# HIDEOUT, UTAH PLANNING COMMISSION REGULAR MEETING (RESCHEDULED)

# Wildhorse Development Concept Plan – Updated

Staff Report/Presentation

# Elk Horn Springs Development Concept Plan – Updated

## Retaining Wall (Up Close)

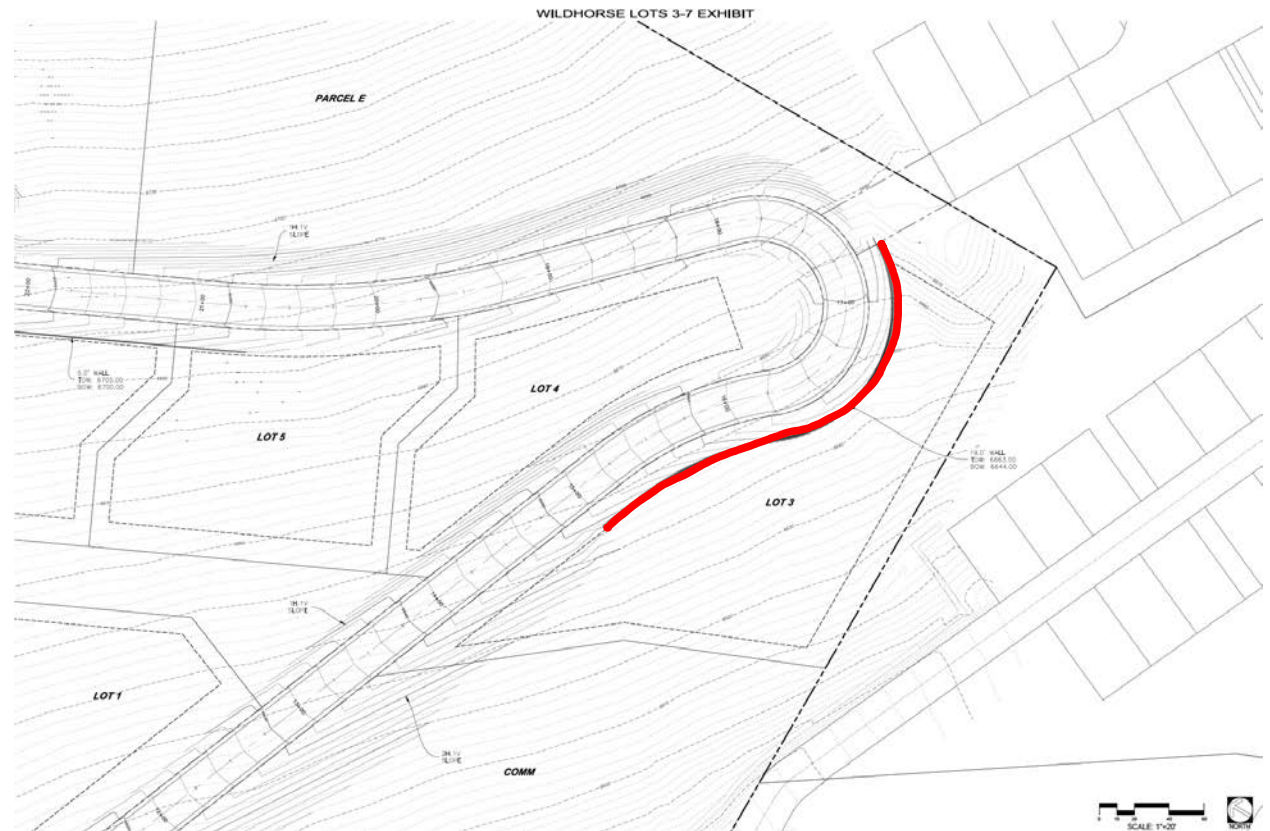
- Lot 3 will include a single-family house that will screen some of the proposed wall's height

## Turn-Around at the Top of the Residential Development

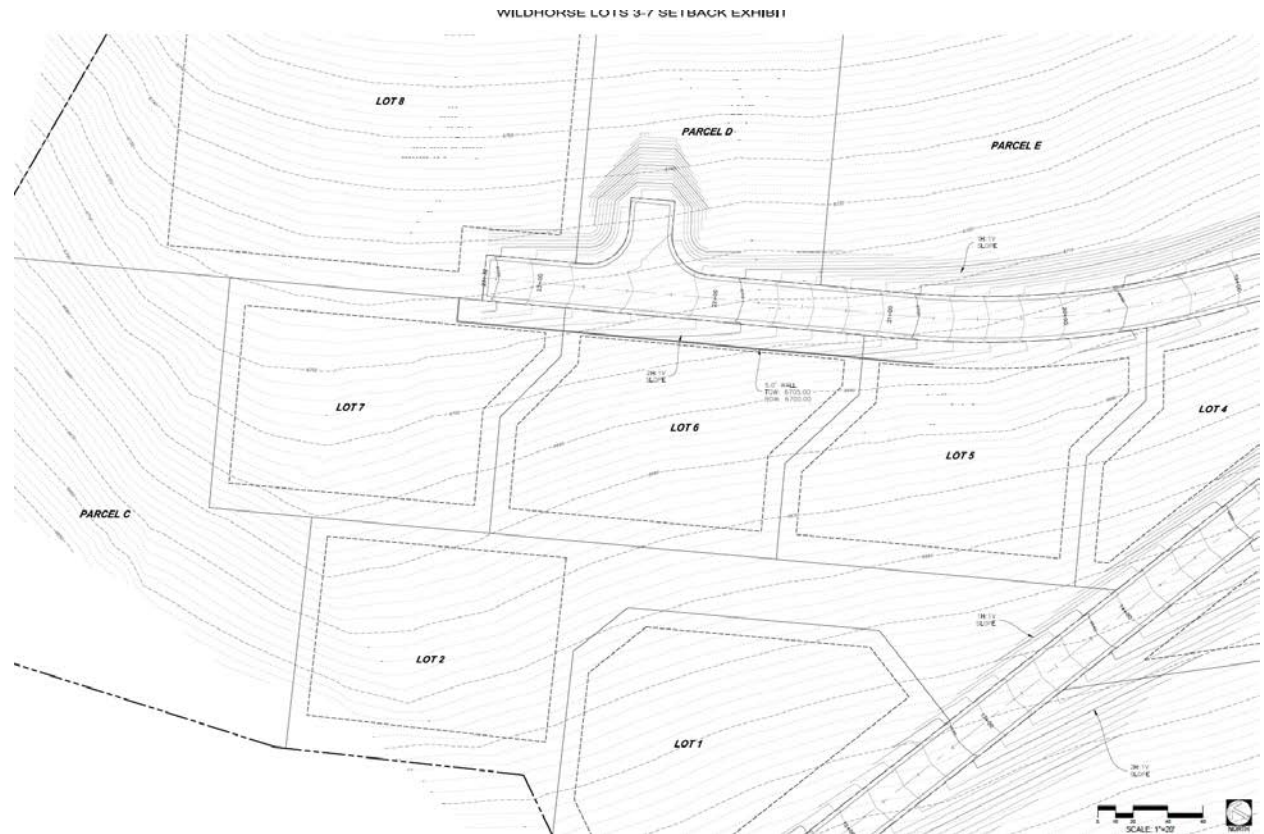
- Applicant to describe the proposed conditions
- Is this envisioned to be bedrock cut back to provide a natural sloped retaining wall? What is the proposed slope: 2H:1V?

## Road Cuts

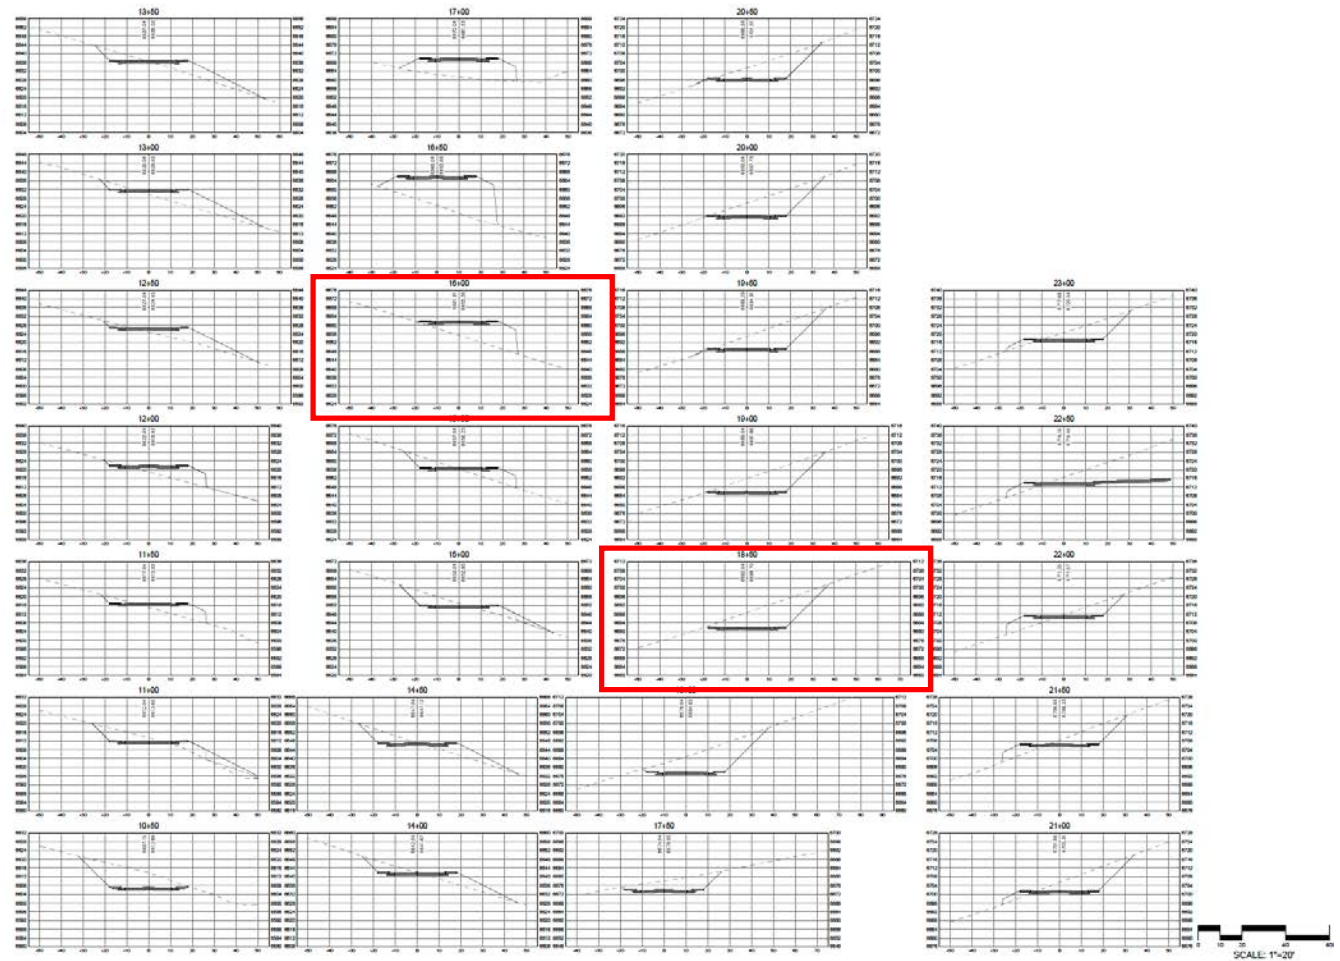
- There will some steep side slopes and scarring to complete the road up to the single-family lots.
- What is the final treatment proposed?
- Is vegetation proposed to be planted in these areas where possible?

## Consideration of 3 – 5 Villas

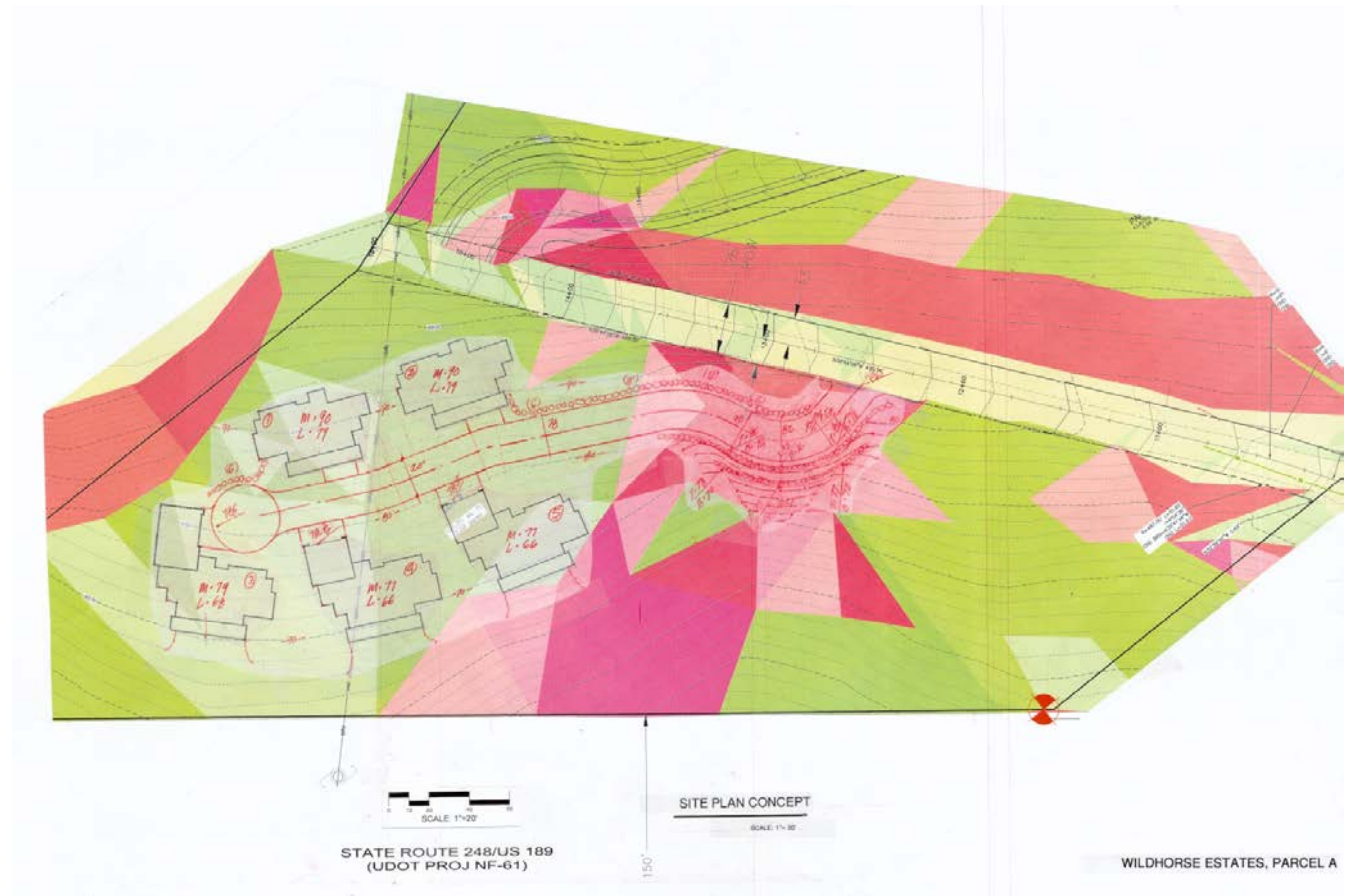
- Smaller residential units proposed on the site just below Woolf Road
- Steep slopes necessitate significant retaining walls visible to SR248
- Does the PC support accessing from a higher point to avoid impacting the steep slopes and reducing the density to 3 units?

## Community Center, Commercial Buildings Pickleball Building, and Stacked Flats

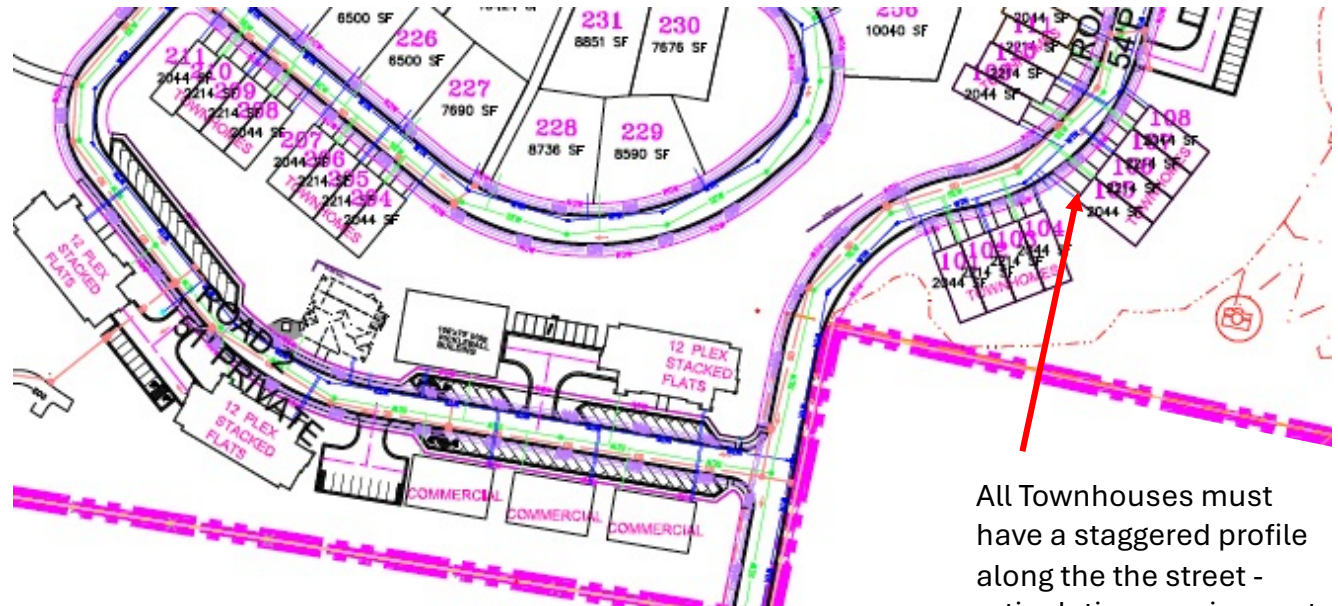
- At the request of the PC, three buildings with stacked flats were added to the neighborhood center area – 36 units.
- Will the Applicant build these, or will these rights be sold to a sub-developer? Precedent images shall be provided to the PC, along with design standards.
- What is the the timeline for construction of the community center, commercial buildings, and stacked flats?
- At platting, the Applicant will need to define this area in detail...in particular, the commercial area to be dedicated to the Town. This is also true for the +/-15 acres of protected open space on the south side of the site.

All Townhouses must have a staggered profile along the the street - articulation requirement

## Sensitive Lands and Topo

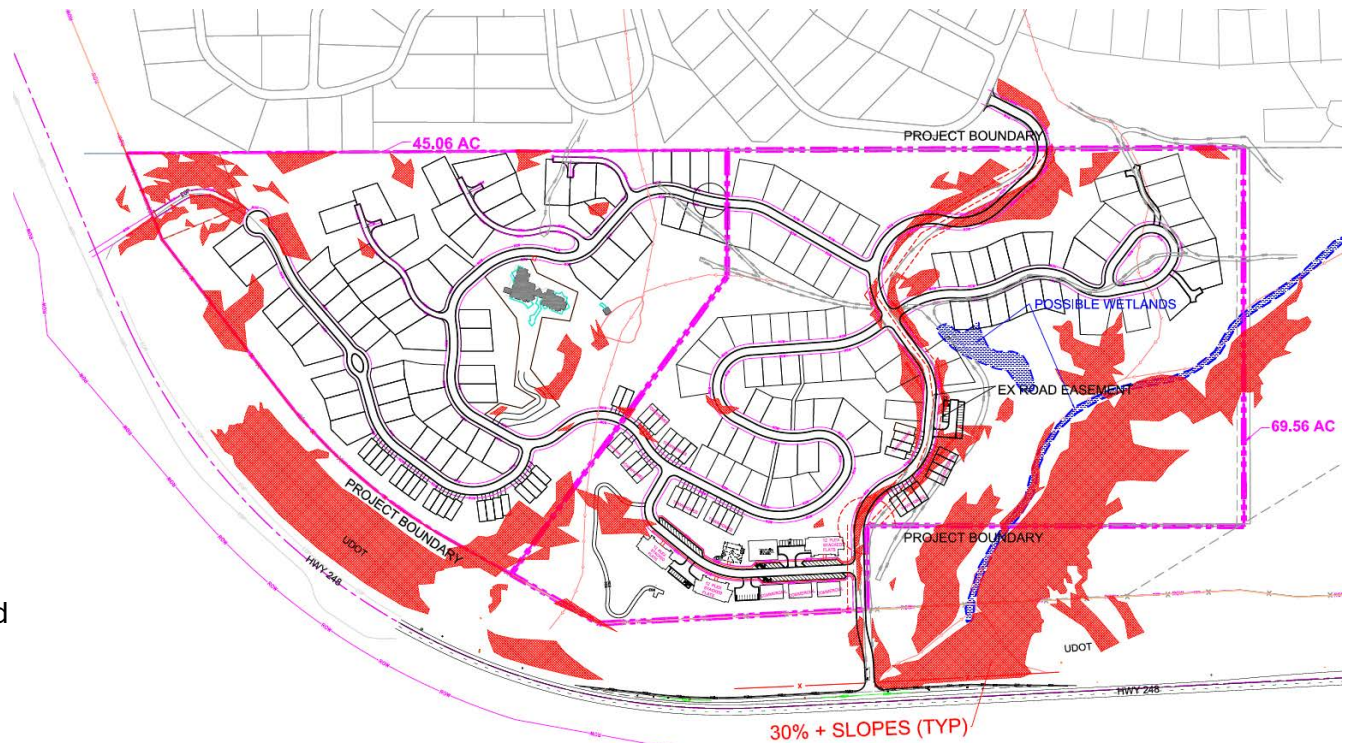
- The areas in red indicate slopes of greater than 30% and designated unbuildable per the Town Code.
- Is the PC supportive of including an exception in MDA, if the proposed project is approved, to allow for some lots and some road infrastructure to disturb 30%+ lands?
- The Applicant shall provide estimated cut and fill. It appears a significant amount of cut will need to be removed from the site.

## UDOT's Wildlife Corridor Planning

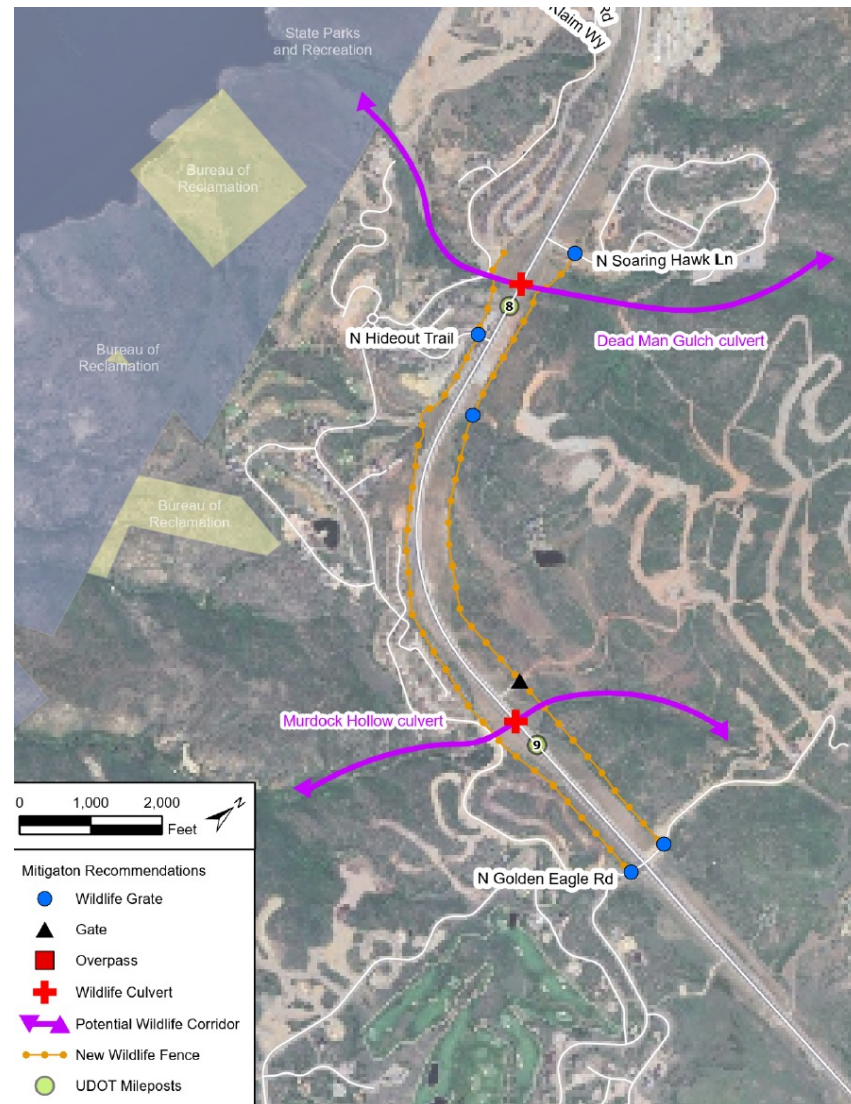
- UDOT has identified two essential Wildlife Corridors in Hideout.
- Dead Man Gulch – between Soaring Hawk and Golden Eagle – a corridor under SR248 – then down Dead Man Gulch south of Shoreline to the Jordanelle.
- Murdock Hollow - from Golden Eagle, to the area on the south side of Elk Horn Springs – under SR248 to the area just south of Rustler to the Jordanelle.
- These areas must be fully protected.

## Aerial Image w/ Site Context

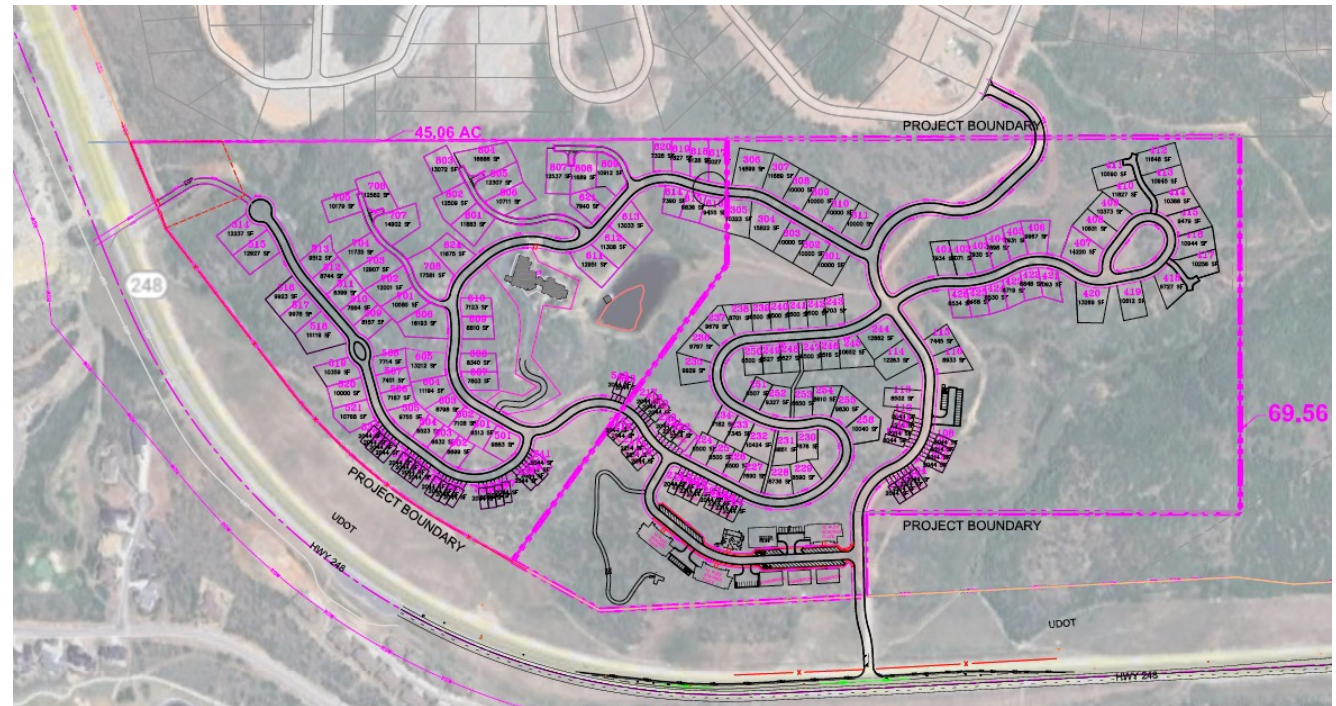
- The area is heavily vegetated and strict Limits of Disturbance (LOD) will be required.
- In addition to LOD requirements for road and stormwater drainage, LODs shall be required for each buildable lot to ensure preservation of native vegetation and existing topography.
- The lots are generally much smaller than Golden Eagle (generally +/- 0.5 acre).

## Project Phasing

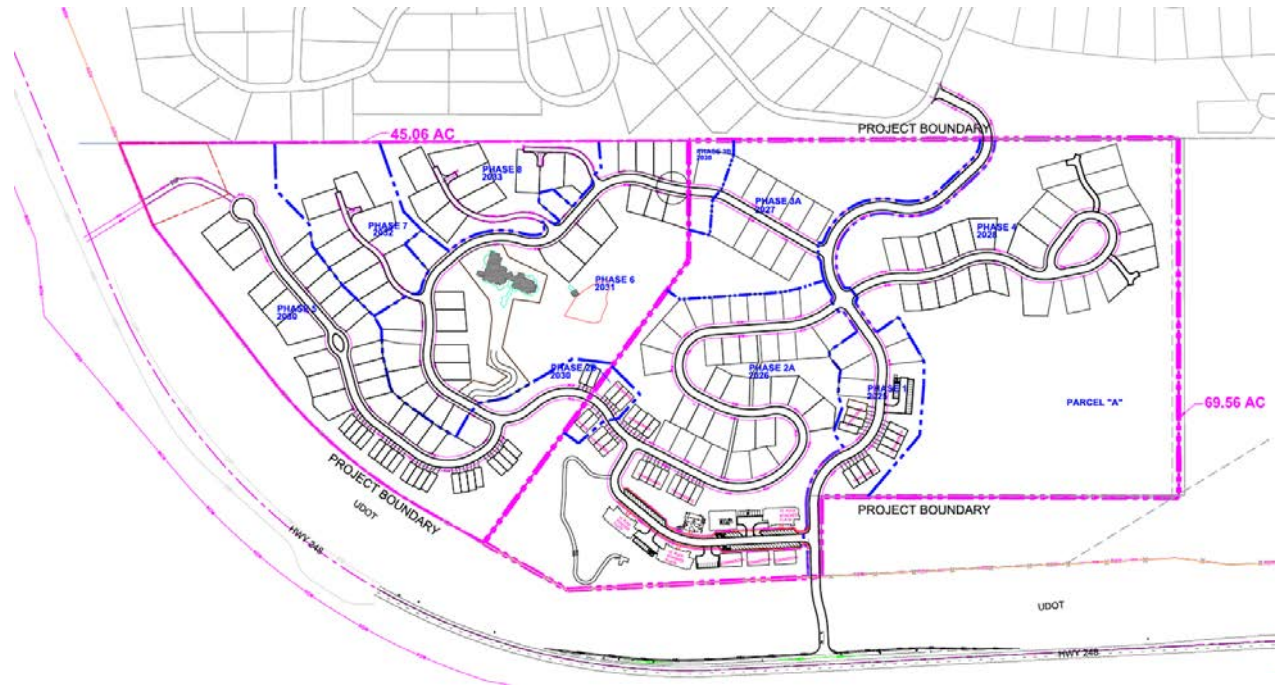
- The Applicant proposes an 8-year build out for the project.
- Is the base neighborhood commercial and stacked flats proposed as part of Phase 2 or Phase 6?
- The Phasing Program appears to build out some of the lower elevations first and then move up the mountain. The PC should weigh in on this. The impacts of construction traffic will continuously impact the homes in the earlier phases. Consider reversing the phasing?

### Main Road

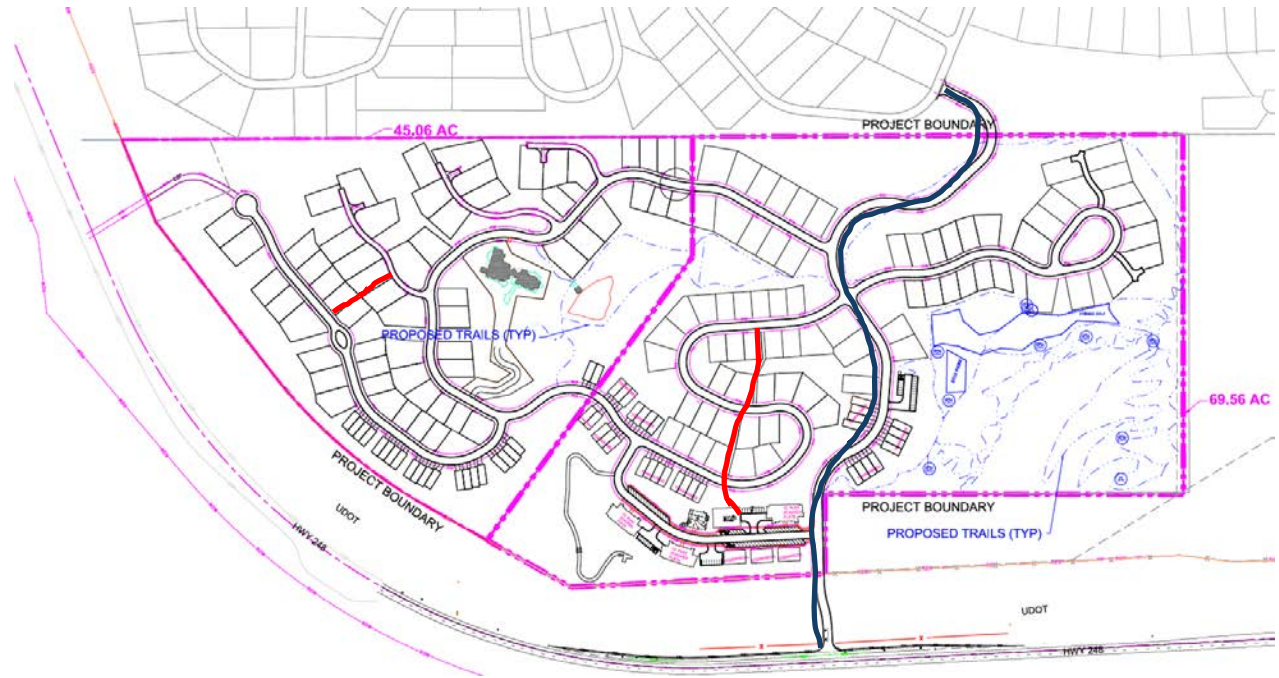
- *The proposed primary road is the existing emergency road constructed by Mustang Development for Golden Eagle. Has the Applicant coordinated with Mustang relative to this easement that runs through Elk Horn Springs (in blue)?*
